**PLANNING BOARD AGENDA**

**NOVEMBER 7, 2022  
REGULAR MEETING**

**Re: Zero's Enterprises, Inc.  
Completeness/Technical Review No. 3  
703 16<sup>th</sup> Avenue  
Block 22, Lots 22, 23, and 24  
H2M Project No. LKCP 1802**

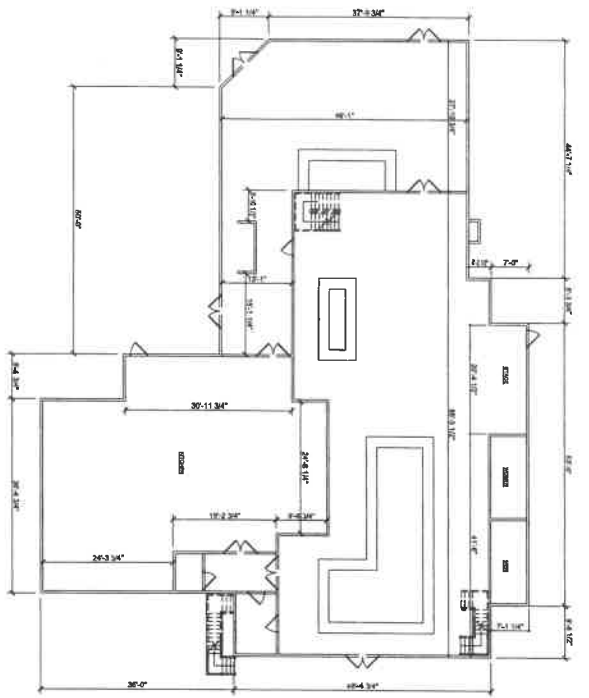
The Board should note that despite the project characterization provided above, I am unclear about the extent of the proposed application. I do not believe that Note #3 on the Site Plan squares with the original application documents or the architectural plans cited above. I believe that Board should elicit testimony regarding the full extent of the proposed conditions (and any additional relief that they may require) before advancing to the specific items addressed below.

1. It is my understanding that the Applicant was to consolidate a number of lots through previous Board approval(s). However, the Site Plan depicts individual lots and calculations based on those individual lots. The Board should elicit testimony regarding these circumstances to clarify the record, and, in the event of an approval, require the Applicant to file a revised Site Plan reflecting the testimony provided and condition any approval on the consolidation of those lots.

Lastly, the Site Plan identifies the side setback at Green Street as 5 feet required, and 5.07 feet existing. By definition, the Green Street side of the principal structure is actually a Front Yard, requiring a 20-foot setback. While this inaccuracy does not affect the proposal, the plans should be revised to reflect this distinction.

4. The Site Plan depicts a dumpster area, area west of the volleyball courts. The Board should elicit testimony regarding the circumstances of this feature (including dumpster sizes, location, enclosure and security). Also, it appears that there is a shed associated with this area. The Board should elicit testimony regarding this structure as well. Lastly, the Board should also elicit testimony regarding vehicular access to the dumpster area in light of the proposed parking lot expansion set forth on the Site Plan (which seemingly precludes such access).

5. Code Section 17-10.7 sets forth the off-street parking requirements for uses throughout the Borough. I believe the Site Plan correctly calculates the existing and proposed parking burden (255 spaces and 261 spaces, respectively) and provides an accurate "proposed" parking count (200 spaces) if the application is approved. In the proposed condition, a variance will be required for the proposed non-conforming parking provision (261 spaces required, 200 provided).

An issue that is linked to the provision of the proposed 200 spaces is the reliance on the parking lot to the west of the railroad tracks, which technically affords 89 spaces. I am unaware of the legal mechanism provided to ensure the use of that lot in perpetuity and it has become clear that that lot rarely affords the total number of spaces credited here as it is cluttered with various vehicles and construction equipment, thereby reducing the actual usefulness of the lot. The Board should elicit testimony regarding the legal mechanism to link the off-site lot to the Bar-A property and further inquire as to how the Applicant will operate that lot in the future to afford maximum availability of the spaces there.

## PROPOSED PLAN & EXTERIOR ELEVATIONS

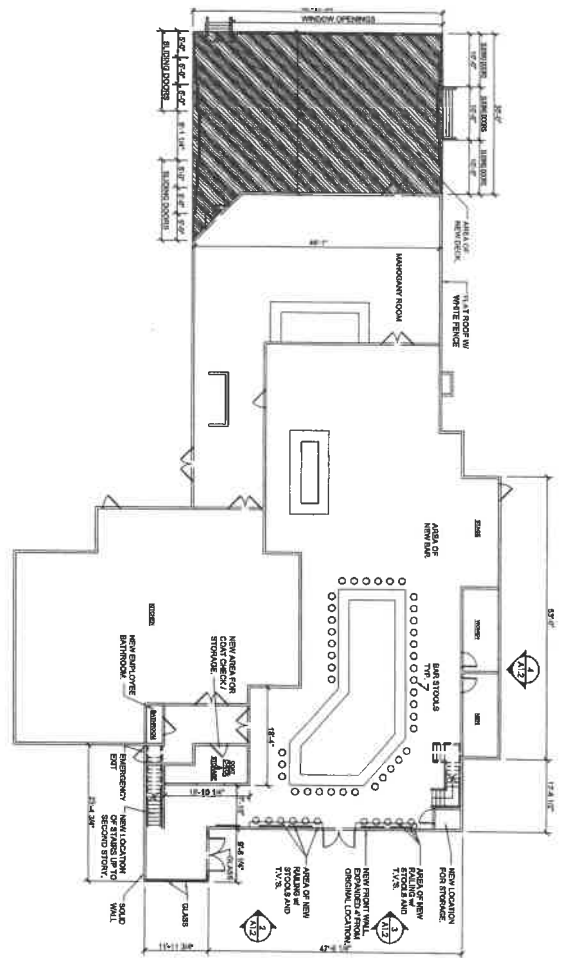
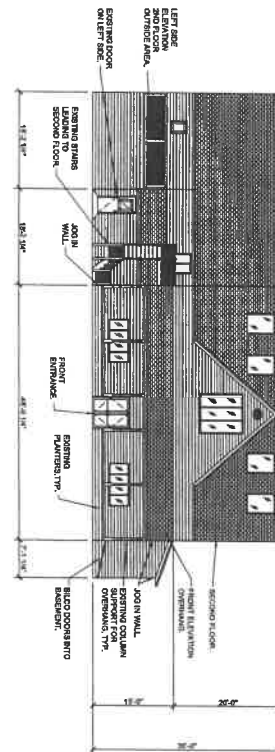
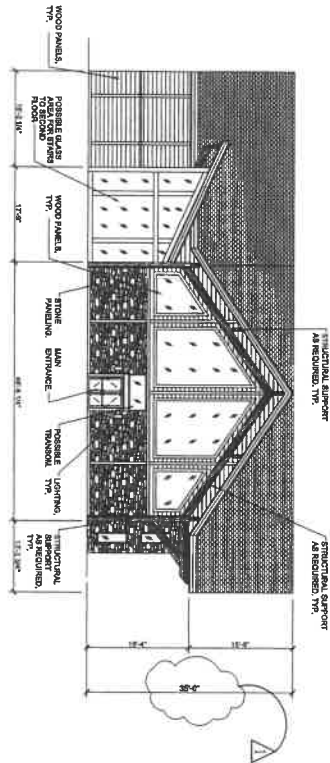
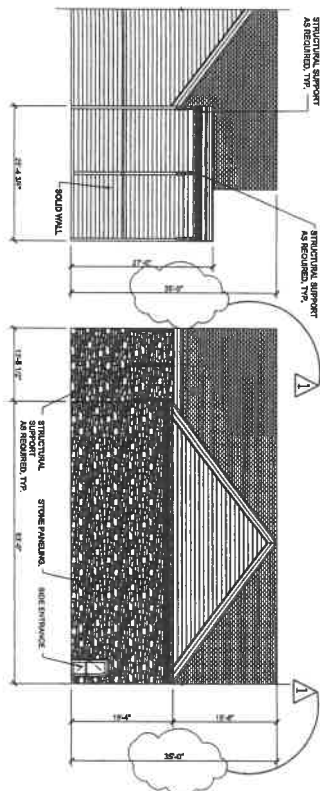
2. Code Section 17-9.3(e) sets the maximum building height for structures in this Zone at 35 feet. The Applicant's plans do not provide enough information to accurately determine the proposed Building Height (which is measured from the top of curb elevation at the midpoint of the front lot line). Notwithstanding, the proposed front addition to the building scales both 35 feet and 39 feet above adjacent grade (depending on which elevation view is scaled). Calculating the proposed Building Height by the Ordinance definition (by referencing both the Architectural and Engineering Plans) yields a proposed height of either 37.1 feet or 41.1 feet. I believe the Applicant's intention is the former, in which case the front addition still exceeds that which is allowable. Accordingly, a bulk criteria variance will be required for the proposed front addition. The Board should confirm this intention through the course of the public hearing. Also, in the event the Board grants approval, the Board should condition that approval such that the architectural plan scale properly and that the corresponding information also makes its way on the engineering plan as well.

3. The architectural plans depict an expanded railing above the enclosed deck at the rear of the principal structure. It is not clear why this railing is necessary. The Board should elicit testimony regarding that second-floor deck, including access and intent for use.

Also, the scaled distances of this second-floor deck area between the architect's plans and the architect's elevations are not the same. The Board should elicit testimony regarding this discrepancy and require revised plan be provided to address same.
